RE: Coors and Central – 100 Coors Blvd NW
Conceptual Grading Plan
Engineer's Stamp Date: No Stamp Date
Hydrology File: K10D017

Based upon the information provided in your resubmittal received 12/14/2017, the Conceptual Grading and Drainage Plan is approved for action by the DRB on the Site Plan for Building Permit.

RE: Coors and Central – 100 Coors Blvd. NW.
Conceptual Grading Plan
Engineer Stamp Date: No Stamp Date
Hydrology File: K10D017

This letter is in response to your comments by letter dated December 11, 2017. The comments have been addressed as follows:

A1 SECTION A-A
SCALE: 1"=20'

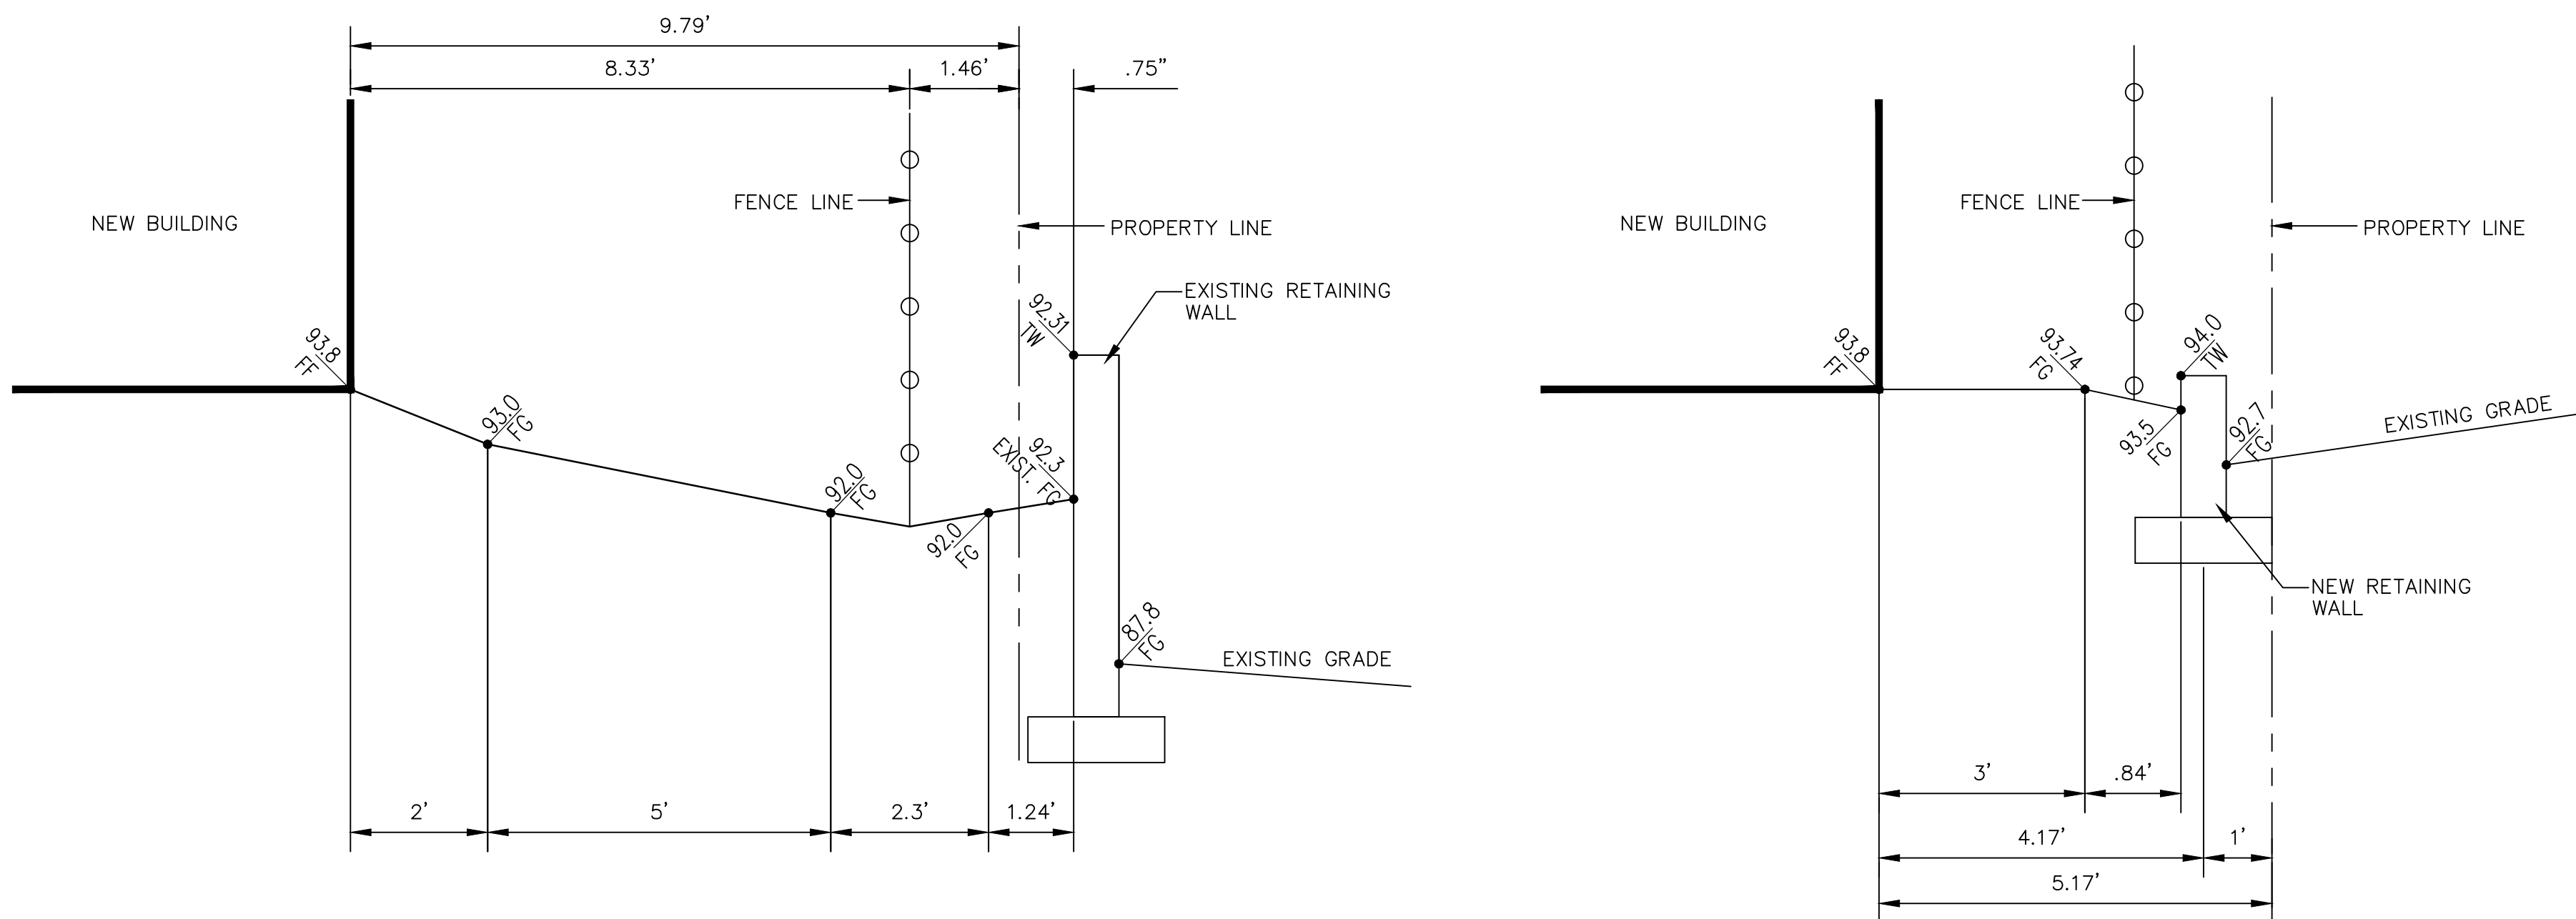
3. Please add the property line in both Section A-A and Section B-B.

4. Please also show the retaining wall footer in both Section A-A and Section B-B.

5. Per DPM Ch. 22.5B, grading and construction of retaining walls at or near the property line must demonstrate that the adjacent property is not damaged or its use constrained. Any such encroachment by the wall or grading must be accompanied by written permission of both landowners.

See attached Conceptual Grading and Drainage plan.

See attached Conceptual Grading and Drainage Plan.

Section B-B is the only section with a new retaining wall. Section A-A the wall shown is an existing retaining wall. The retaining wall on the north property line is placed so that the entire wall and footing is within the property line, as seen in section B-B on Conceptual Grading and Drainage Plan attached.

A1 CONCEPTUAL GRADING AND DRAINAGE PLAN
SCALE: 1"=20'

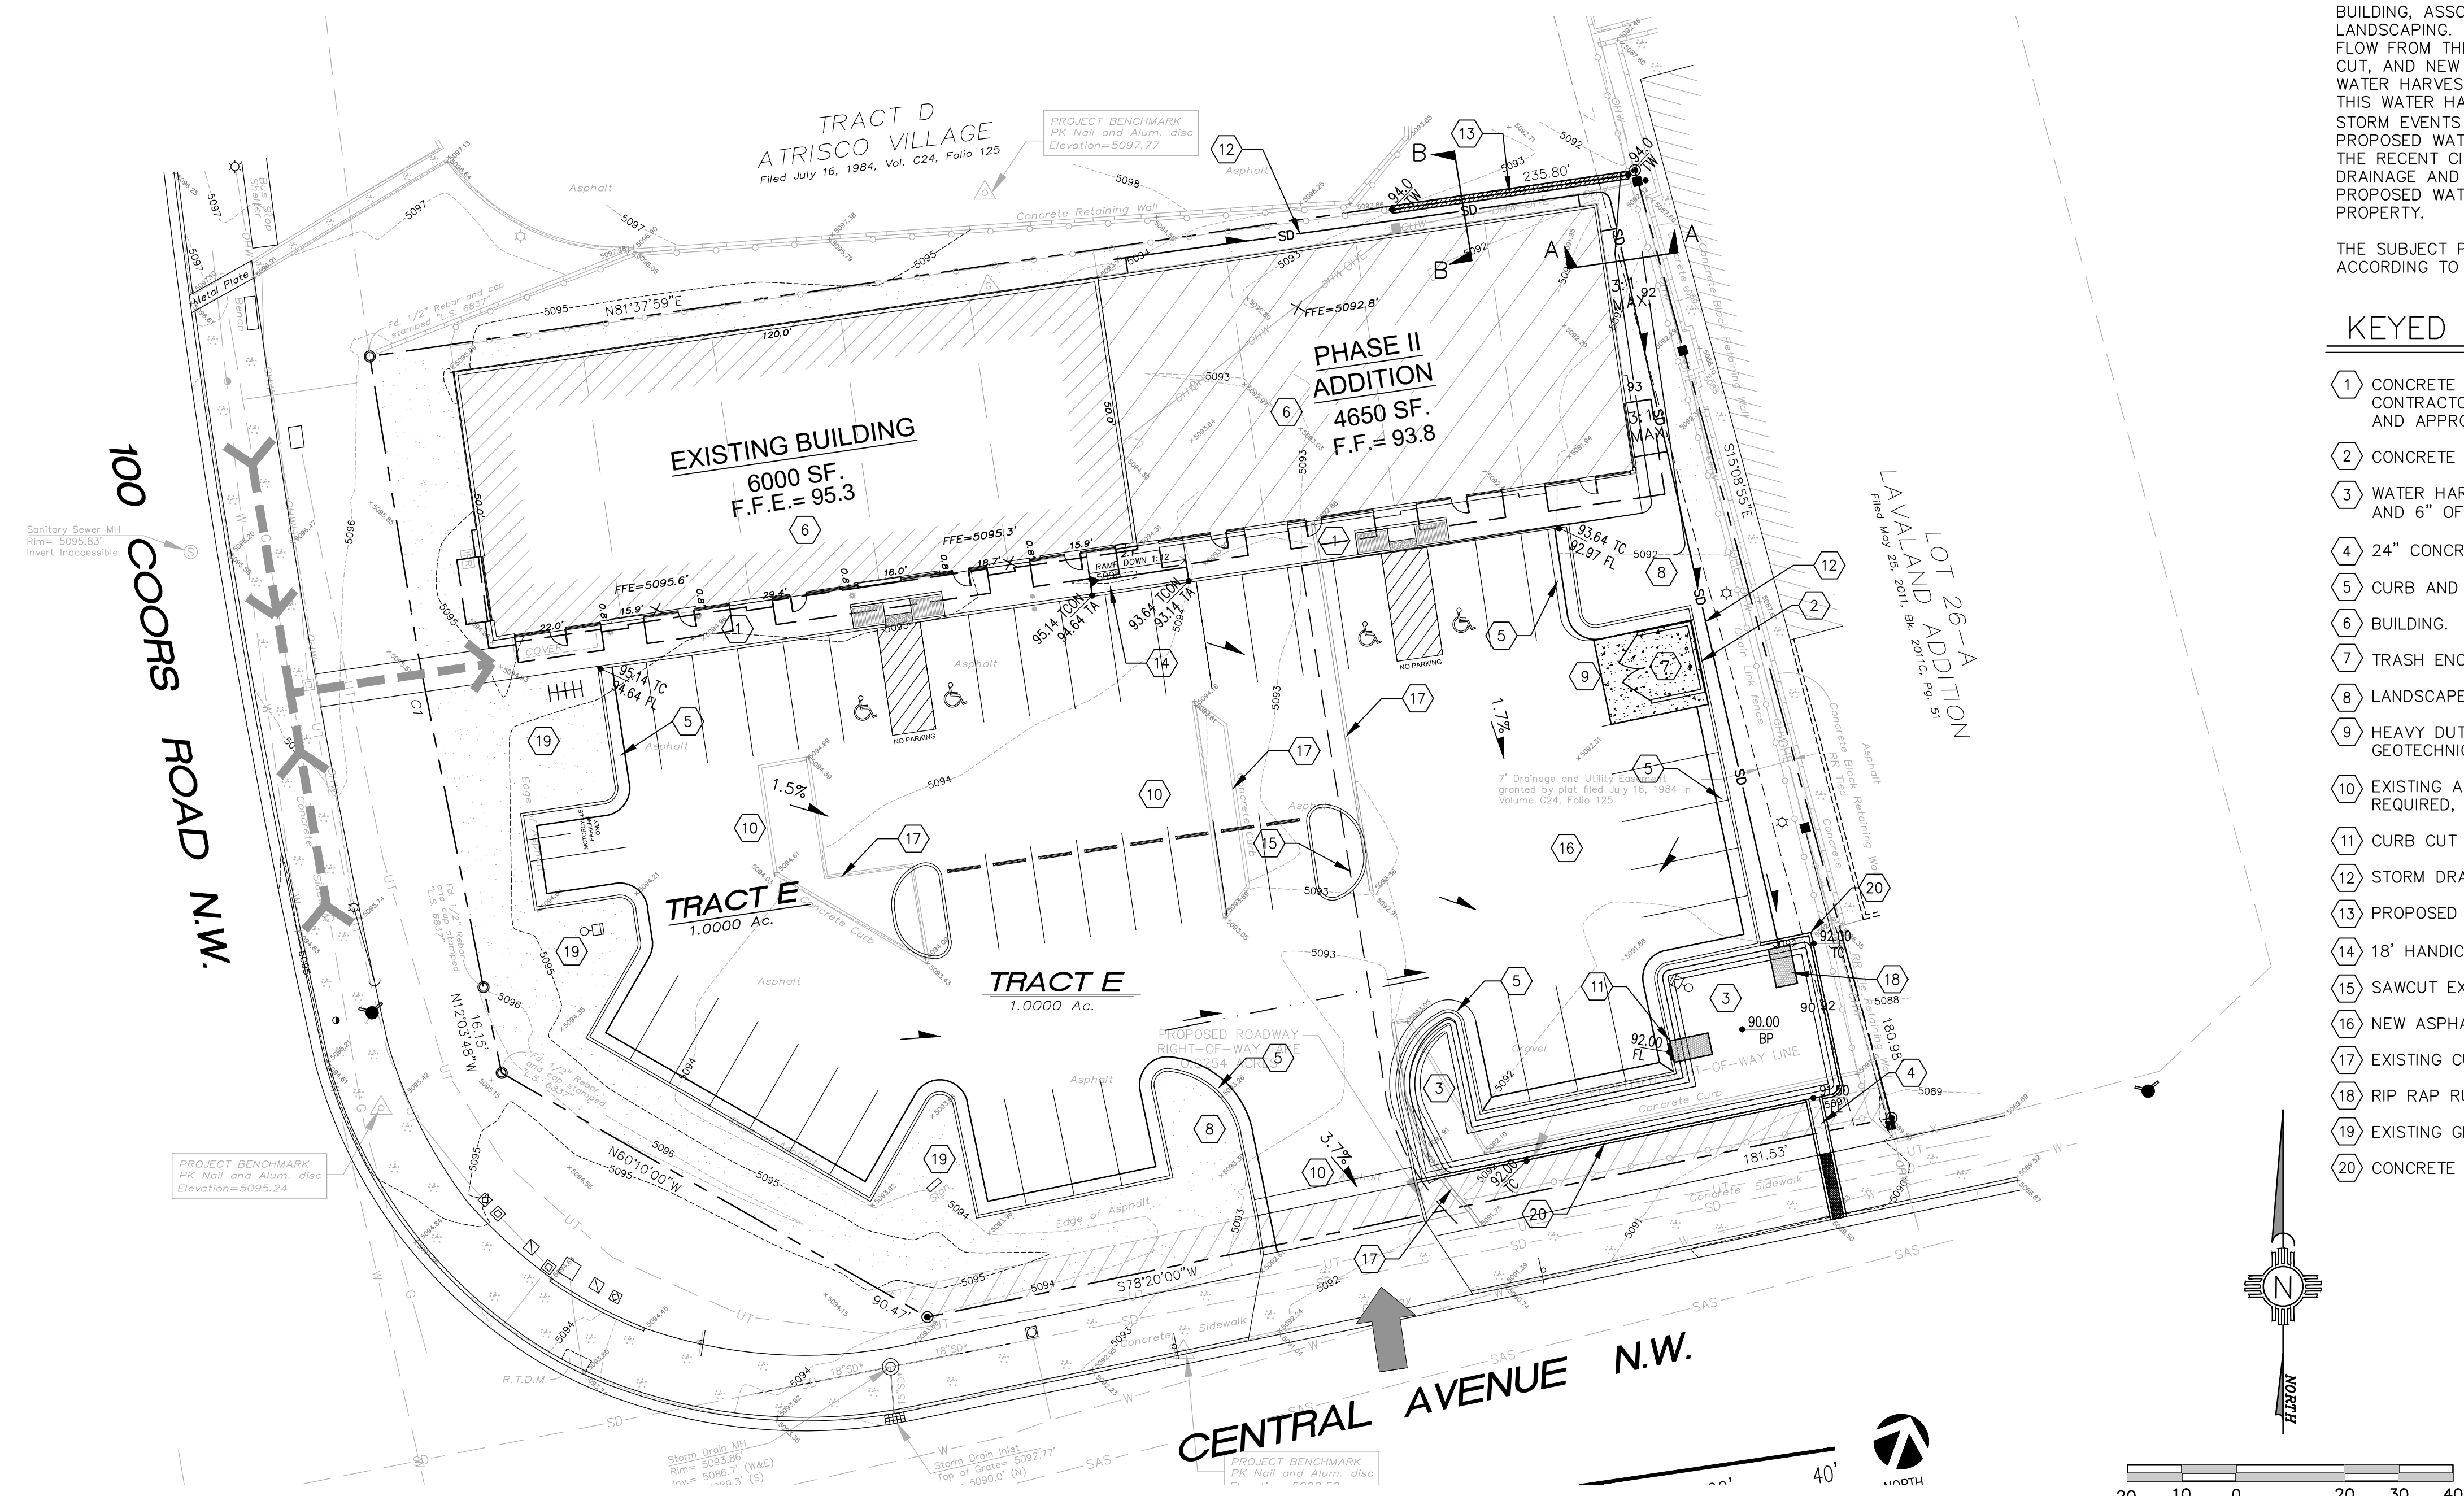
1. Please provide the FIRM Map and flood plain note with effective date.

2. Please provide a vicinity map showing the location of the site. Typically this is the Zone Atlas. This can be downloaded in pdf format from the City of Albuquerque's website.

6. Per Transportation's DRB comments on December 6, 2017, the overall site plan will have some changes and some will affect the drainage. Please insure that the Conceptual Grading Plan matches the Site Plan for Building Permit.

See attached Conceptual Grading and Drainage Plan.

See attached Conceptual Grading and Drainage plan.

The Architect met with Raquel from Transportation and all of the site plan changes required by Transportation are contained on the revised Conceptual Grading and Drainage Plan attached.
